Re: **Amendment to Work Plan for Additional Assessment**
76 Station no. 3538
411 W. MacArthur Blvd.
Oakland, CA

**Subject: Amendment to Work Plan for Additional
Assessment
76 Service Station No. 3538
411 West MacArthur Boulevard
Oakland, California
Alameda County LOP Case No. R0251
Delta Project No. C103538051**

**FIGURE 2
SITE PLAN (REVISED)**

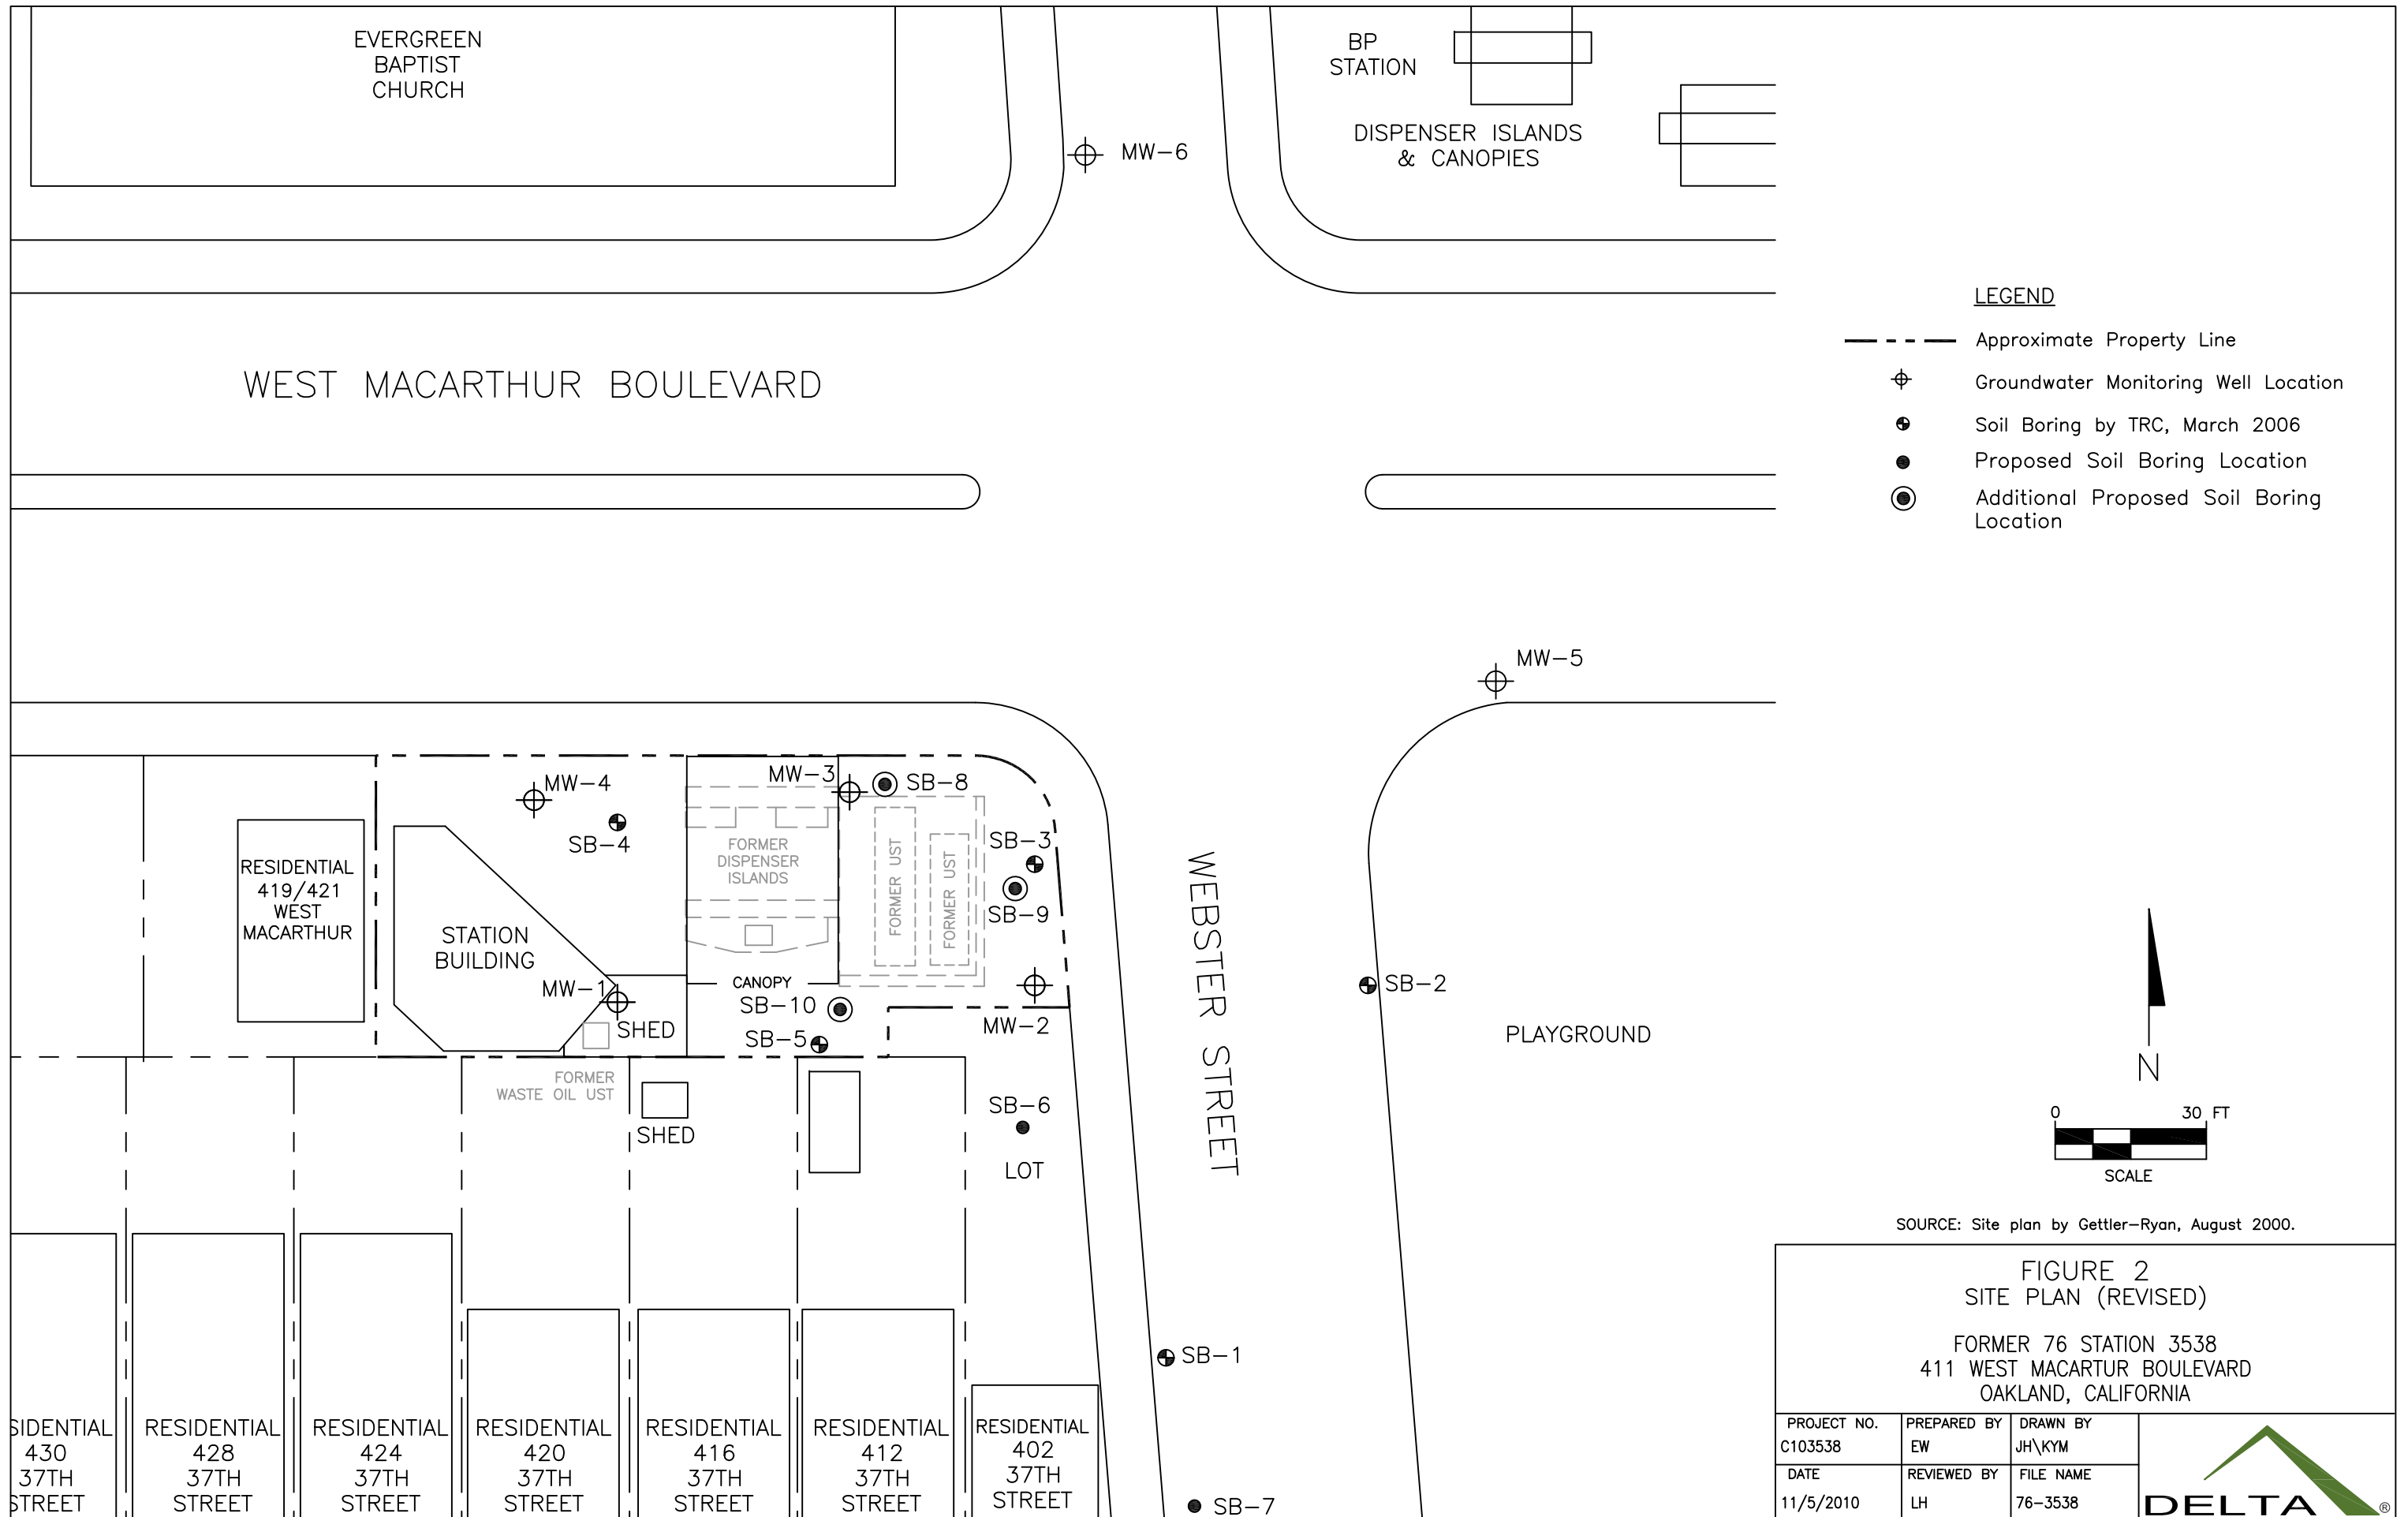
The proposed scope of work may be implemented provided that the modifications requested in the technical comments below are addressed and incorporated during the field implementation. Submittal of a revised Work Plan is not required unless an alternate scope of work outside that described in the Work Plan and technical comments below is proposed. However, submittal of a map showing the locations of additional borings is required.

1. **Soil and Groundwater Characterization** – In addition to the proposed off-site sampling location, ACEH requests that you perform a boring downgradient of the source area to delineate the vertical extent of groundwater contamination and requests that you determine if the residual concentrations of benzene detected in soil in MW-3 and SB-3 are still present. If they are present please present a plan to assess the vapor pathway at the site in the report requested below.

Delta proposes to advance three additional borings (SB-8 through SB-10) to perform additional assessment in the vicinity of MW-3 and SB-3 and provide vertical assessment of groundwater downgradient from the source area. The source area appears to be in the vicinity of the former underground storage tanks. The locations of these borings are shown on Figure 2, revised to identify the proposed additional borings.

Borings SB-8 and SB-9 will be used to evaluate potential residual benzene concentrations in the vicinity of MW-3 and SB-3. SB-8 will be advanced to approximately 20 feet below ground surface (bgs) with soil samples collected for screening at 5-foot intervals.

As Boring SB-9 will also be used to vertically assess groundwater east of the source area, this boring will be advanced to approximately 30 feet bgs with groundwater samples collected at first encountered groundwater as well as an a discrete depth groundwater sample collected at approximately 30 feet bgs.

Boring SB-10 is to be advanced similar to boring SB-9 as it will provide vertical groundwater assessment southwest of the source area.

Original proposed boring SB-6 will be modified to be advanced similar to borings SB-9 and SB-10 as it will provide additional vertical groundwater assessment south of the source area.
